Planning Application Number: 25/00990/FUL

Application Address: Land Off Station Road, Bagworth

Table 1: LCC Highways Response Tracker (June 2026)

Appendix 1 – LCC Highways Response dated 9th June 2026

Swept Path Assessment for Refuse Vehicle

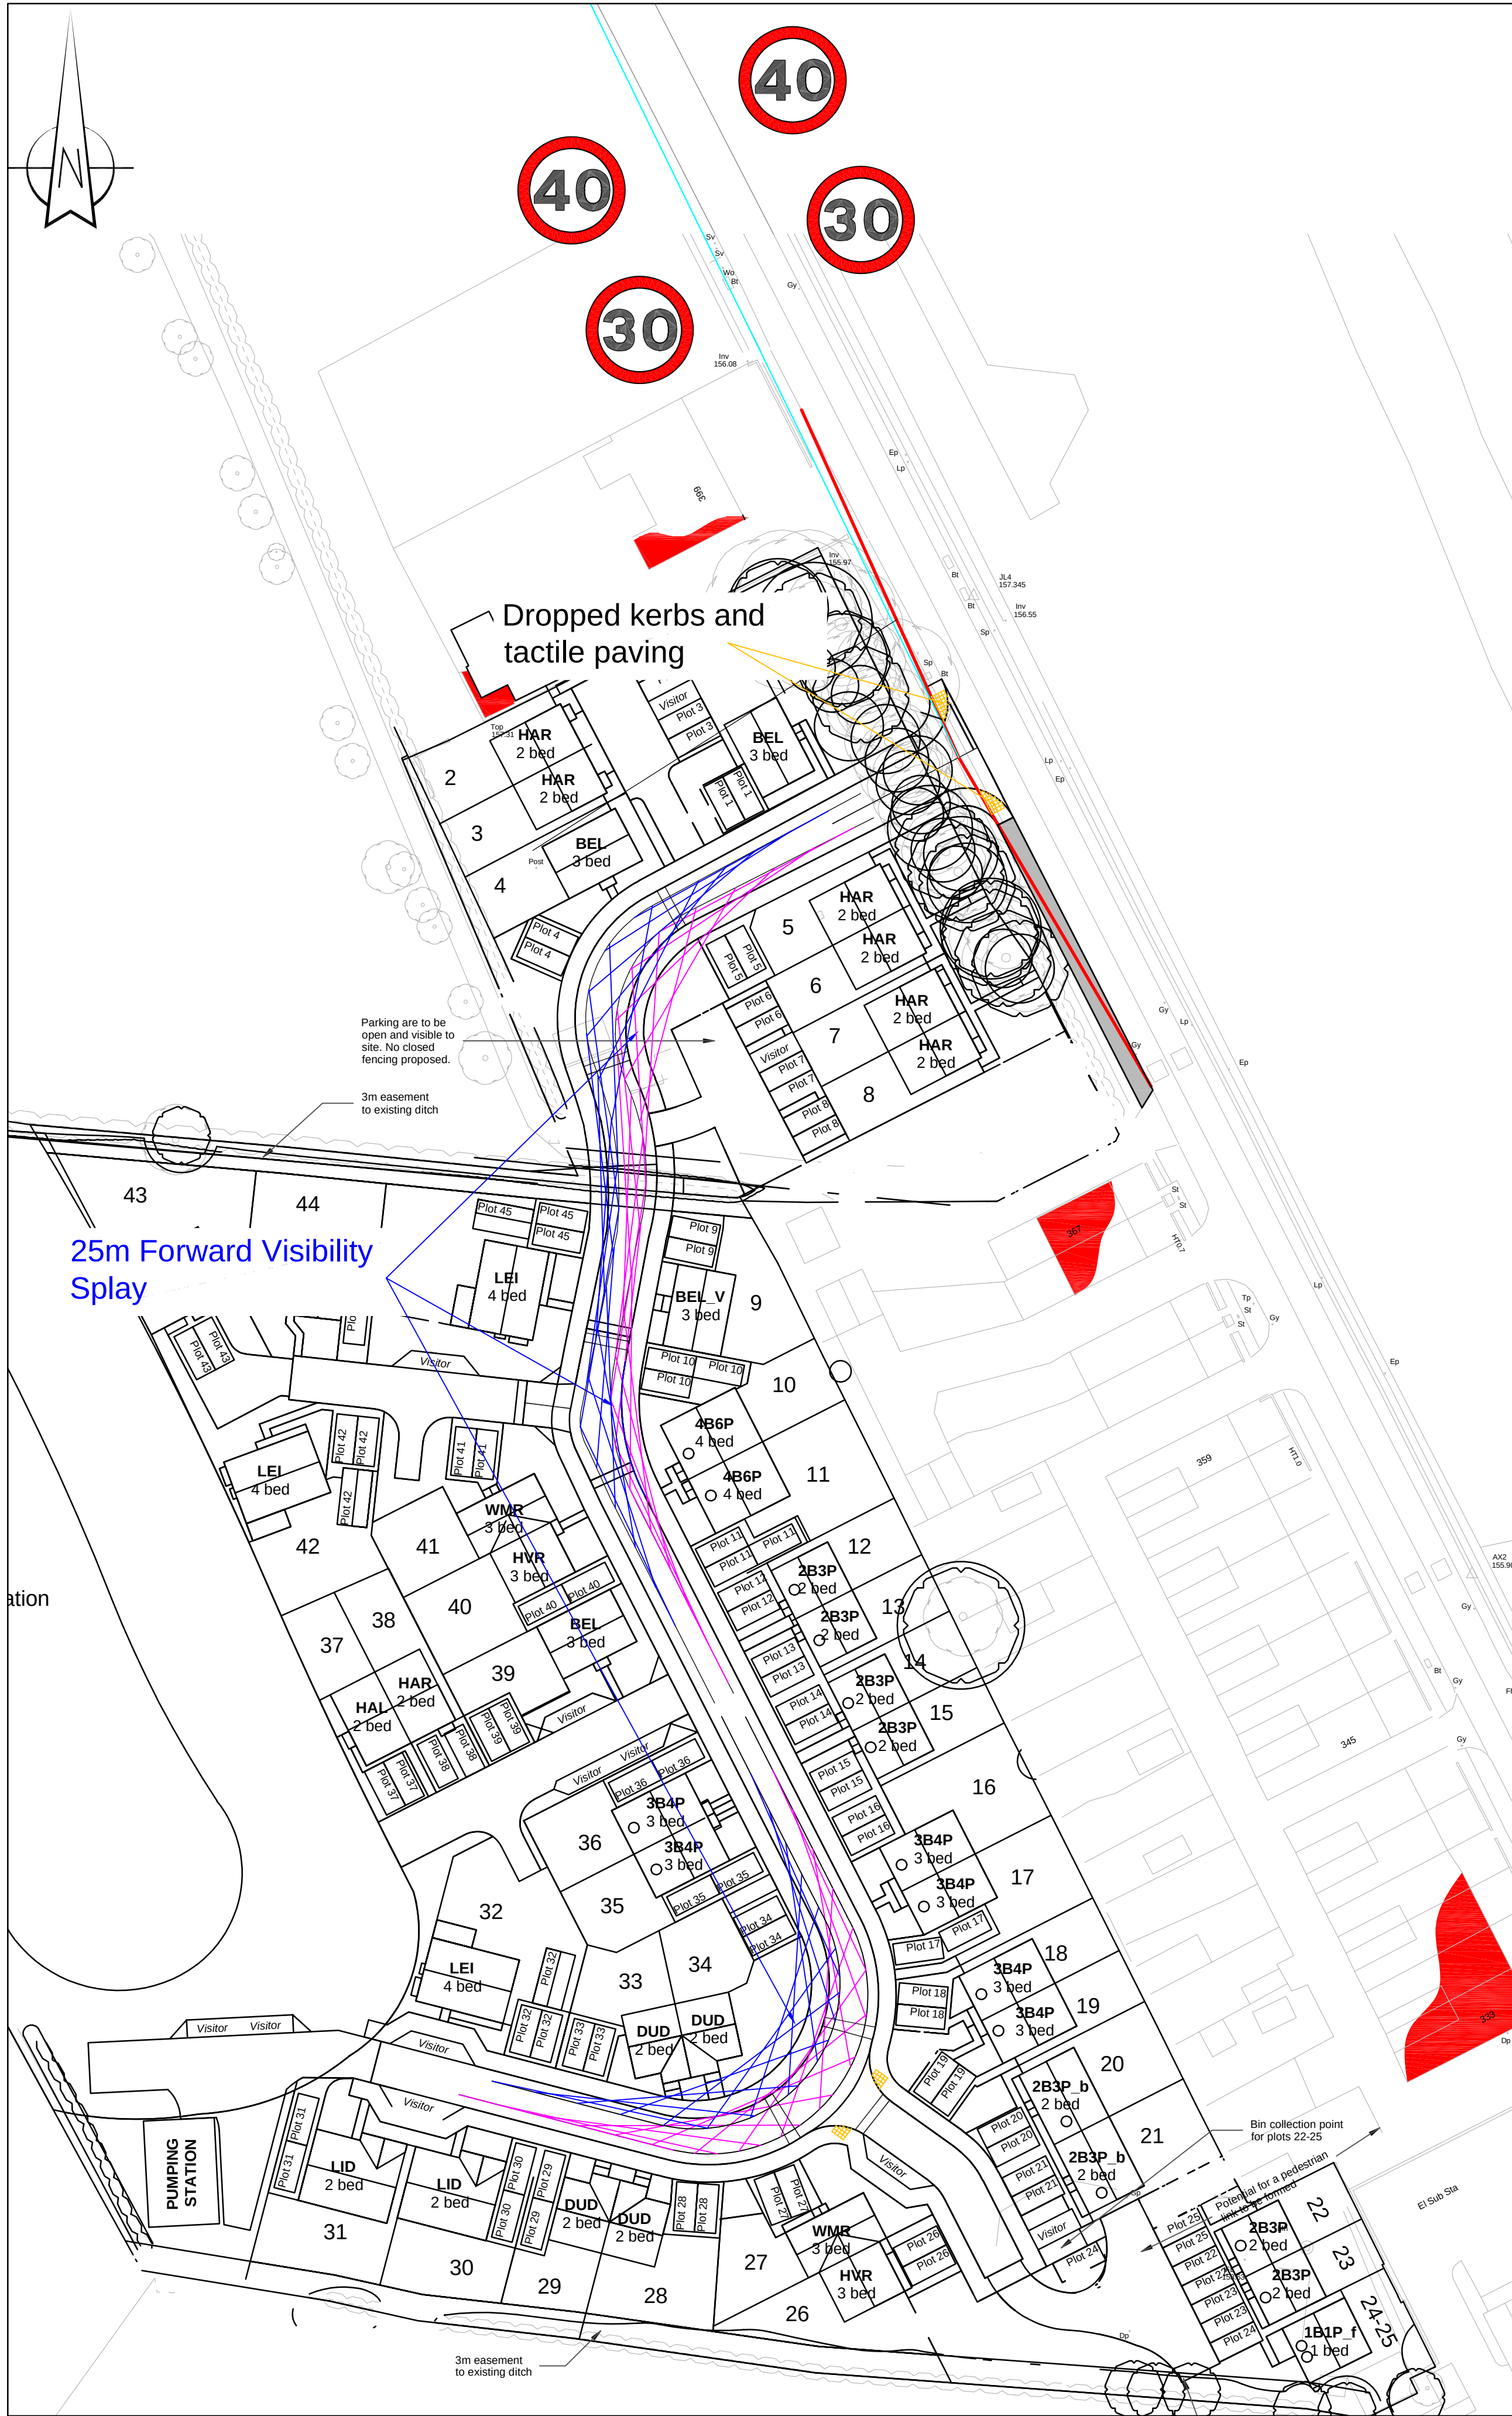
The Applicant should please provide refuse vehicle tracking of the site in accordance with the section of the LHDG titled '[Swept Path Analysis](#)'.

Minimum available intervisibility of 39m between a refuse vehicle seeking to enter the site and a vehicle approaching the give way line (leaving the site)

Dropped kerbs and tactile paving

Extent of proposed new footway along site frontage to connect into existing footway to the south

Drawing Title
Swept Path Assessment Car

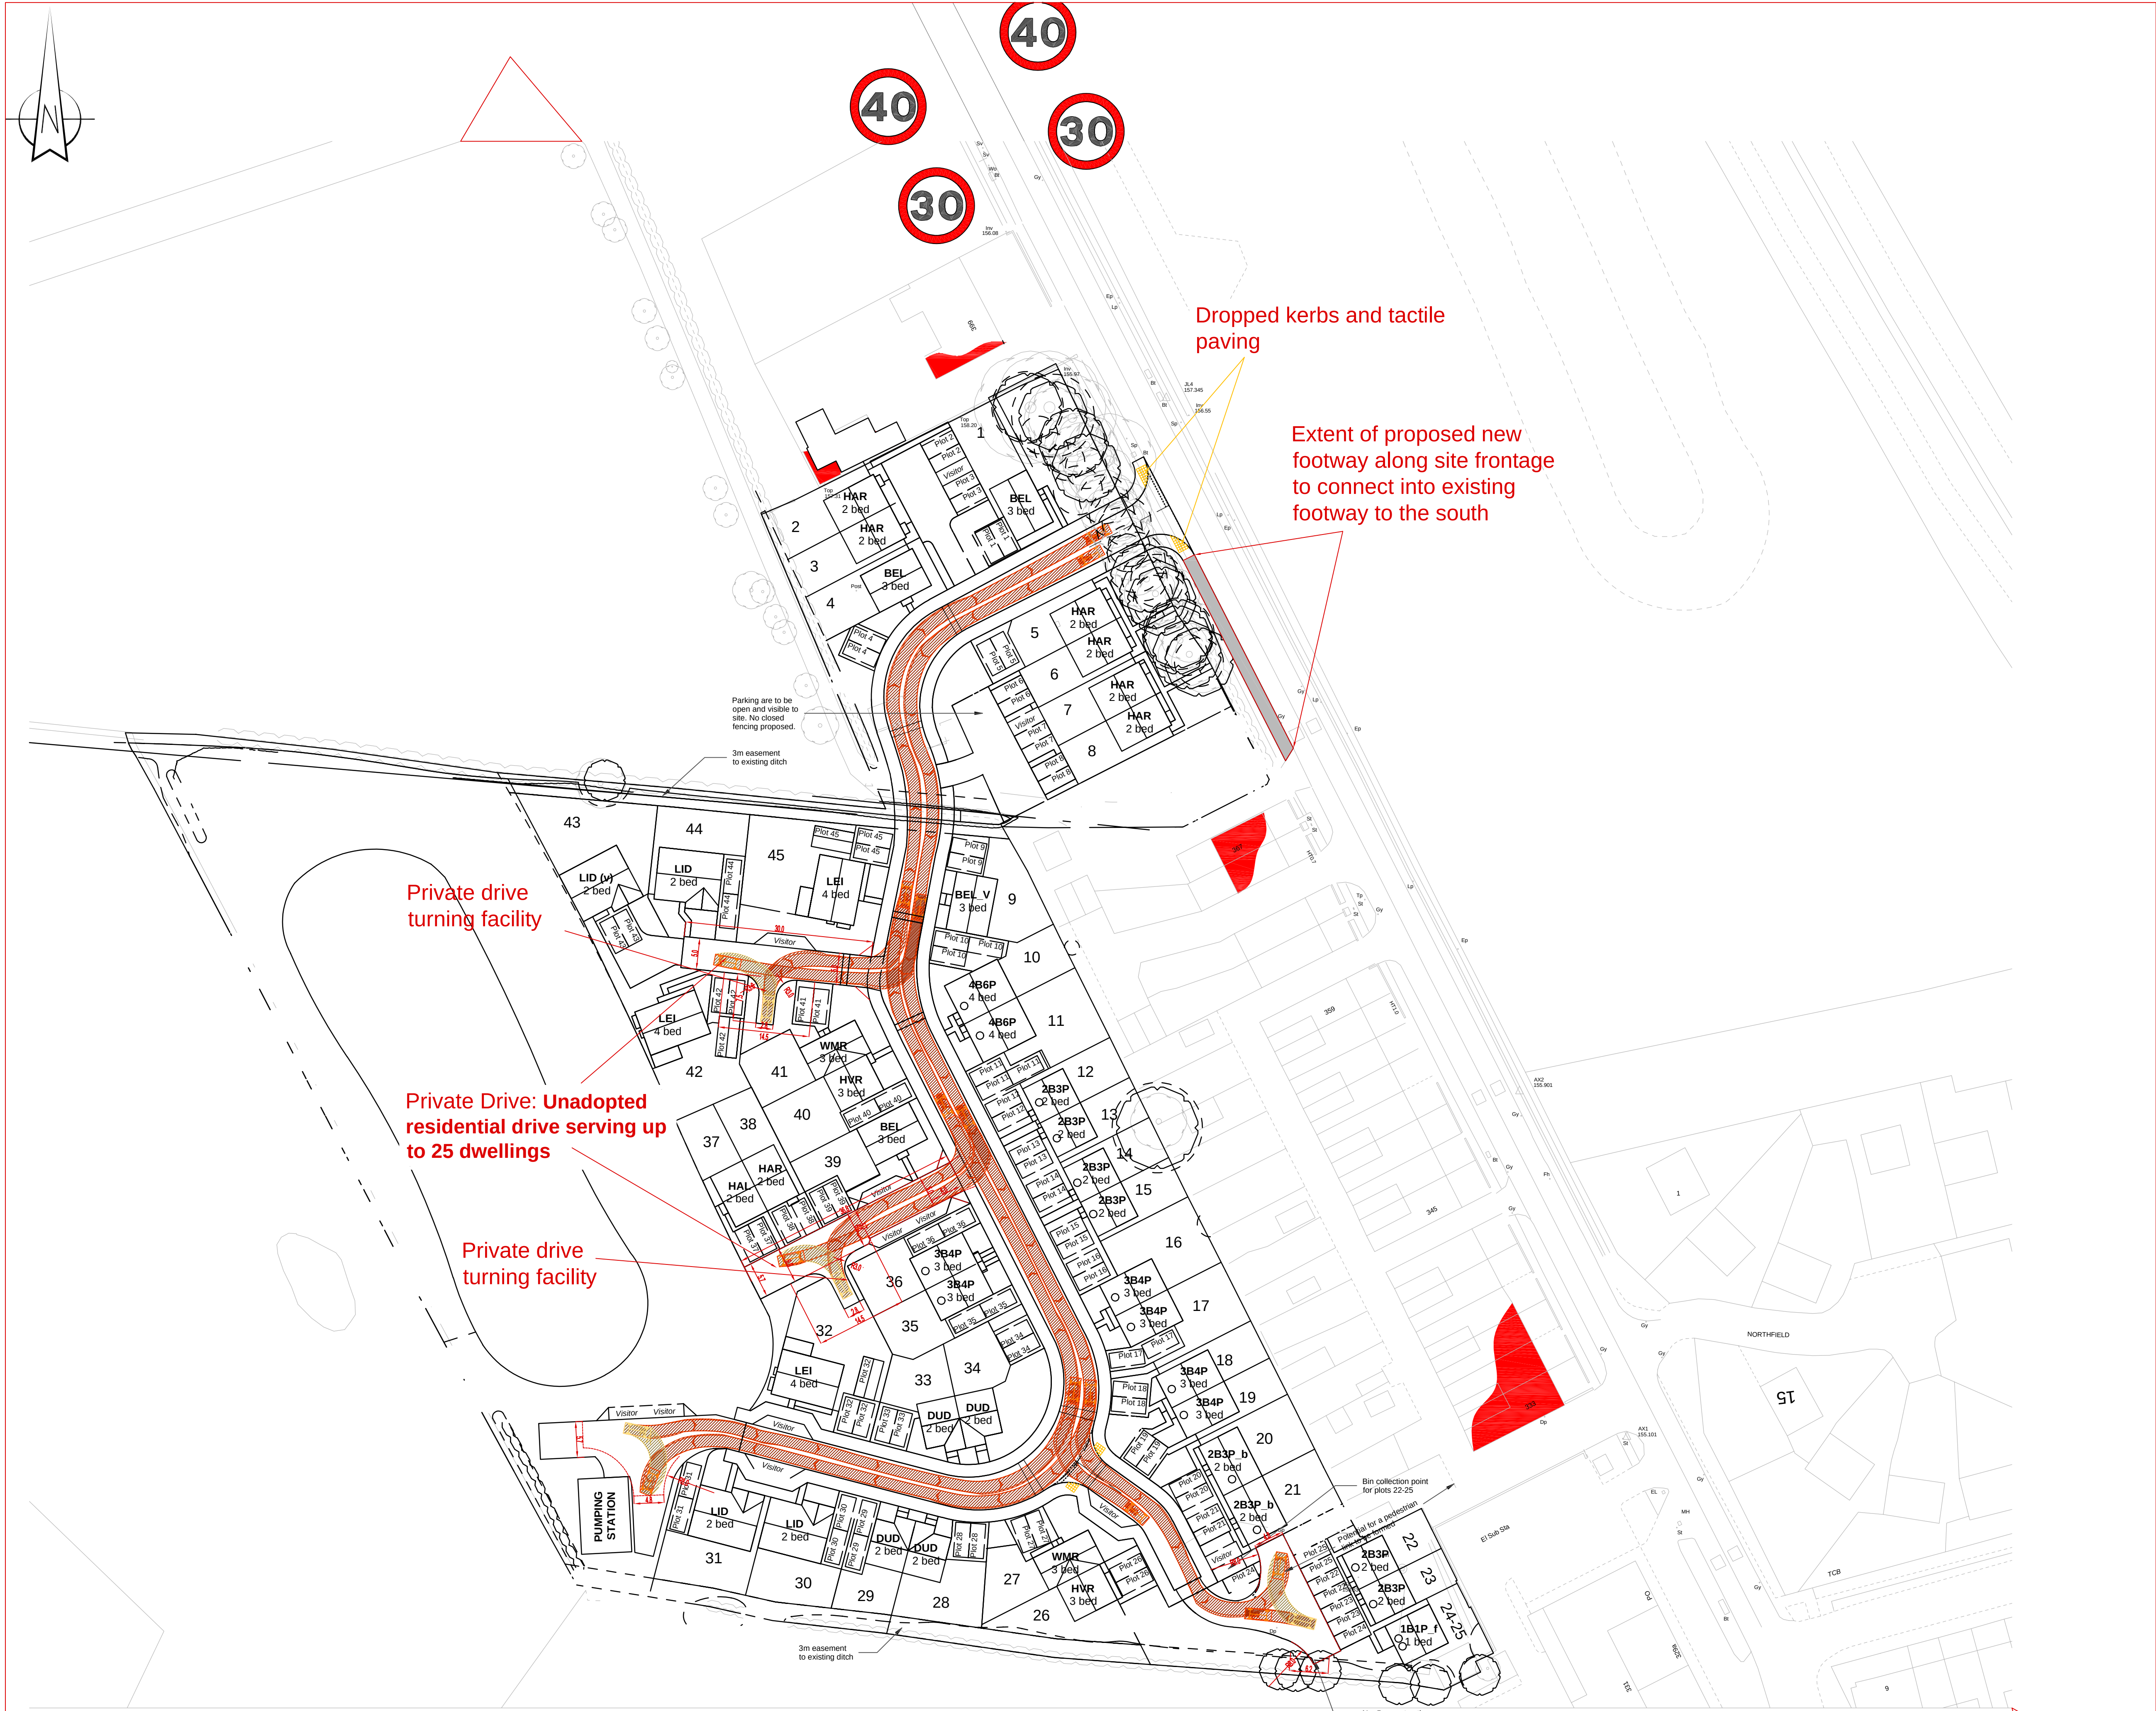
A turning head should be provided at the end of all cul-de-sacs or wherever vehicles would otherwise have to reverse over 20m or more. Please see [Figure 12](#) of the LHDG for further information.

Ref.	LCC Comments	PF Response
	A turning head should be provided at the end of all cul-de-sacs or wherever vehicles would otherwise have to reverse over 20m or more. Please see Figure 12 of the LHDG for further information. The Applicant should please provide refuse vehicle tracking of the site in accordance with the section of the LHDG titled 'Swept Path Analysis'. The visitor parking bays proposed within the highway extents should be removed from the layout, however, if these are to be offered for adoption the Applicant could provide a commuted sum.	appropriate turning-head arrangement. As a result, vehicles are able to enter, turn within, and exit these private drives without the need to reverse more than 20 metres. All vehicle tracking (refuse vehicle, fire tender and car) has been undertaken using a minimum modelling speed of 15 kph in the forward direction and 2.5 kph in reverse, as set out on PF drawings 109538-PEF-ZZ-XX-D-H-00002 P04 and 109538-PEF-ZZ-XX-D-H-00004 P02 presented in Appendix 2. The visitor parking bays are being removed from the layout.
